County of Fairfax, Virginia

STAFF REPORT ADDENDUM

APPLICATION SE 2013-MV-011

PROPOSAL: To retroactively permit the placement of fill in a floodplain and to permit additional fill

HALLOWING POINT RIVER ESTATES LOT 7 SECTION ONE
MOUNT VERNON DISTRICT FAIRFAX COUNTY, VIRGINIA
SPECIAL EXCEPTION PLAN

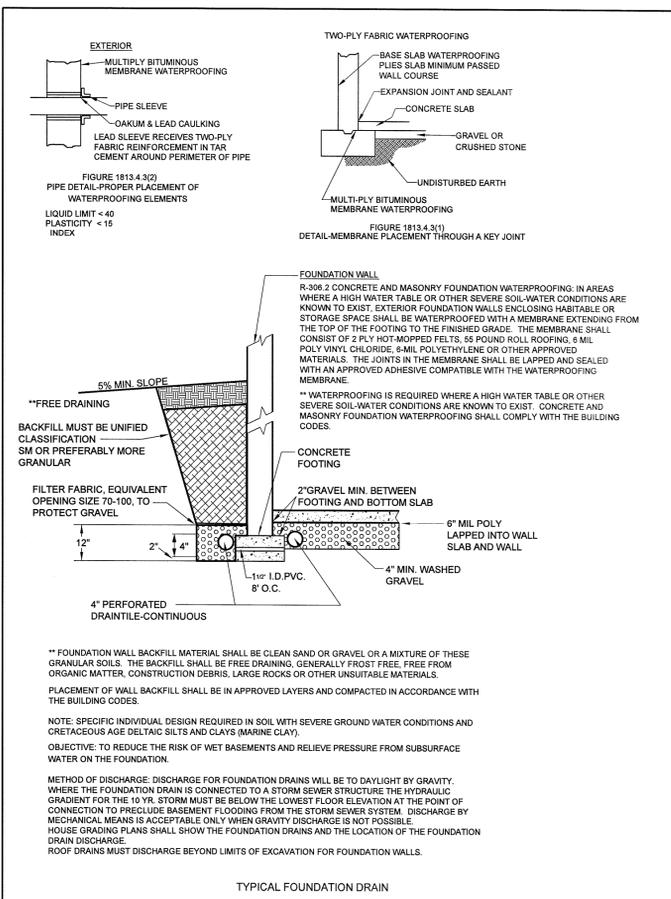
The special exception plans do not include the slope stabilization measures recommended in the letter report by Soil & Structure Consulting. The drawings should be updated to reflect Soil & Structure Consulting's recommendation prior to issuing a permit.
